SUNSHINE COAST REGIONAL DISTRICT

Question and Answers #1

Request for Proposal No. 2636501

Generator – Garden Bay

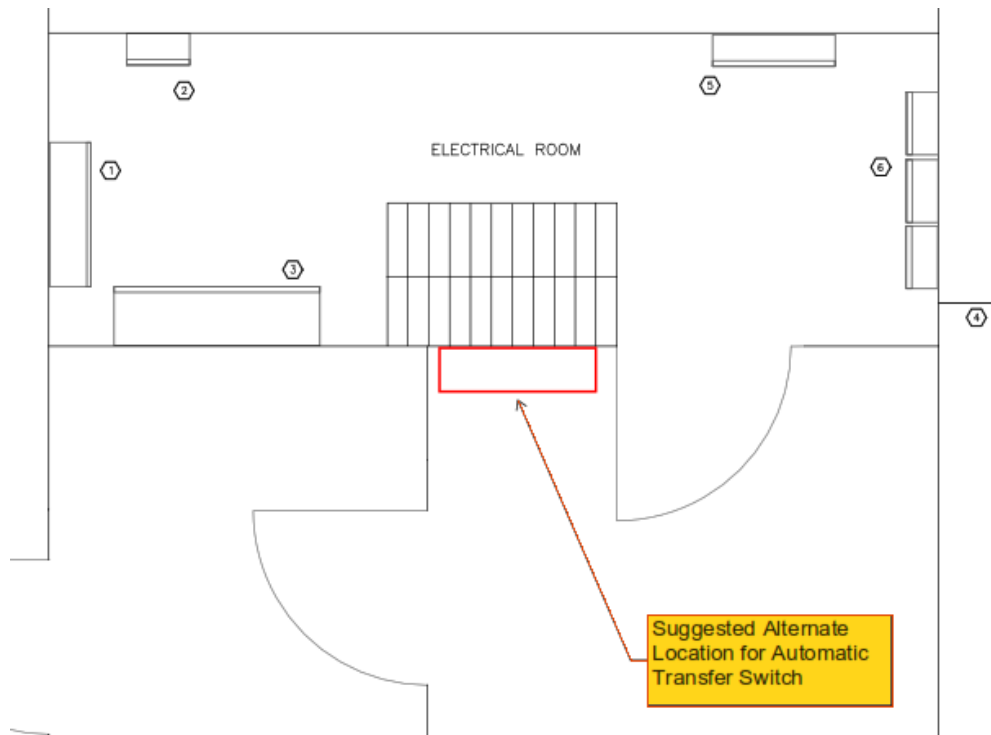
Question: Is there any reason on why the switch has to be in this location specified in the drawings and could not be moved outside of the electrical room to replace the existing obsolete switch? As clearances are tight for proposed auto transfer switch location in the MCC room. Including potential interference from ventilation louvre depending on auto transfer switch size. Can the auto transfer switch be located on the “office” wall where the existing manual switch is located?

Answer: The proposed location was selected to replace the existing manual transfer switch and maintain consistency with the current installation. The automatic transfer switch (ATS) is not required to remain in this exact location.

If an ATS can be selected that meets the required electrical and working clearance requirements within the MCC room, the original location is preferred. If clearance constraints or interferences cannot be resolved, the alternate location shown above is acceptable provided that the ATS enclosure be of type NEMA 3X, if the room is considered an environment with corrosive agents due to the storage of the hypochlorite.

Photo 2 – Existing location of manual transfer switch. See markup below to consider this location as an alternative to the design location.

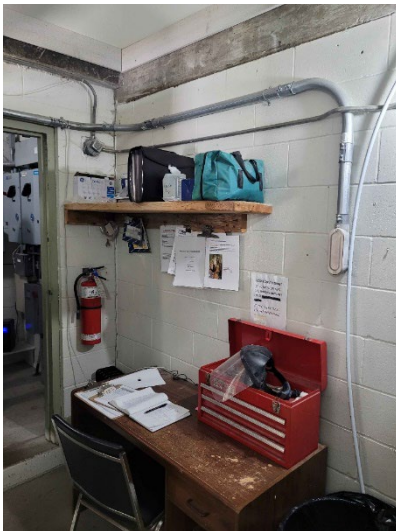
Question: Can the switch be installed in a room where chemicals are being stored such as hypochlorite? See Q&A No.8 for the proposed alternative location.

If room is considered an environment with corrosive agents, then the switch must be installed with a NEMA 3X enclosure as per CEC 4-200.
